**PLAN CHANGE 76**  
**EAST MADDISONS ROAD ROLLESTON**  
**RFI - Urban Design / Landscape Matters**  
**Visual Assessment**

Document Status	FINAL
Author	Nicole Lauenstein
Date	22 March 2021

This Statement has been prepared in response to the Request for Information from SDC dated 11 February 2021.

fig 1- concept plan - indicative layout

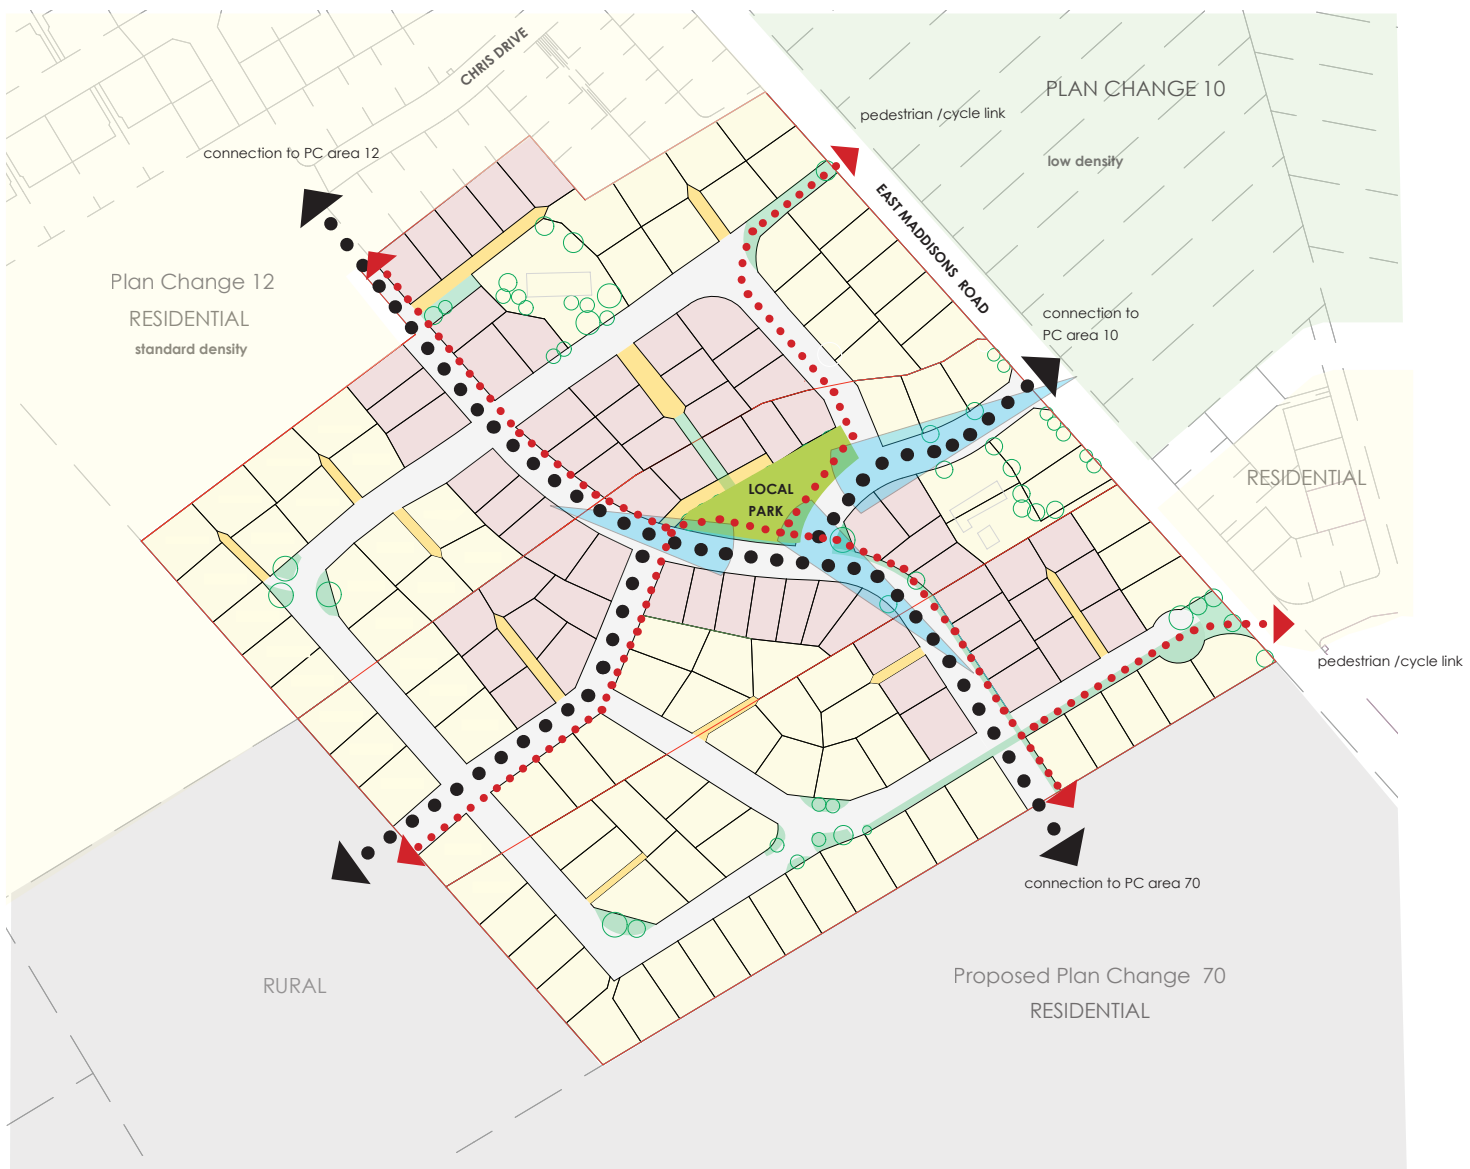
*RFI 9. As previously mentioned, there are a significant number of plan change requests currently lodged with Council, and consideration is required to be given to the position of key movement linkages and reserves between this plan change, the existing environment and other plan change requests. Details of other plan changes can be found on Council's website.*

*RFI 11 The ODP shows a single recreation reserve at the northern end of the development area and the request documents mention "creating a landscape feature for the development by creating a neighbourhood park". However, it does not appear that consideration has been given to the provisions of open space in the surrounding area, including the location of an existing reserve on Chris Drive to the north. The proposed location exceeds the Council's distribution criteria of 500m and, as such, the location of the proposed reserve as shown on the ODP is not supported. However, a neighbourhood reserve (of around 2,000 m<sup>2</sup>) is desirable in this area, but this should be more centrally located and ideally be next to medium density areas. Given this, please either:*  
*a. provide an assessment as to why this location was chosen or the rationale for its need and position; or*  
*b. amend the application as per the above comment.*

- The neighbourhood reserve has been repositioned in a more central location within the ODP area.
  - The following key links are provided:
    - local road links to the existing adjoining urban areas, ODP Area 12 to the north and ODP Area 10 to the east

- The local neighbourhood park will be approx. 2000m<sup>2</sup> and provide a gathering / recreational space for the development. It is located within less than 400m of any new dwelling on site, encouraging pedestrian and cycling movement over the use of cars.

- The Neighbourhood park is strategically located to support the proposed medium density areas. In conjunction with the main roads the park will break the development into 4 quarters creating a clear and legible layout.

- Roads are aligned to create edges to the park on at least two sides providing good public access and passive surveillance.
- The geometry of the park and the roads leading up to it is deliberate, to enable views into the development towards the green space, and at the same time views along the north south road towards the Port Hills in the background.
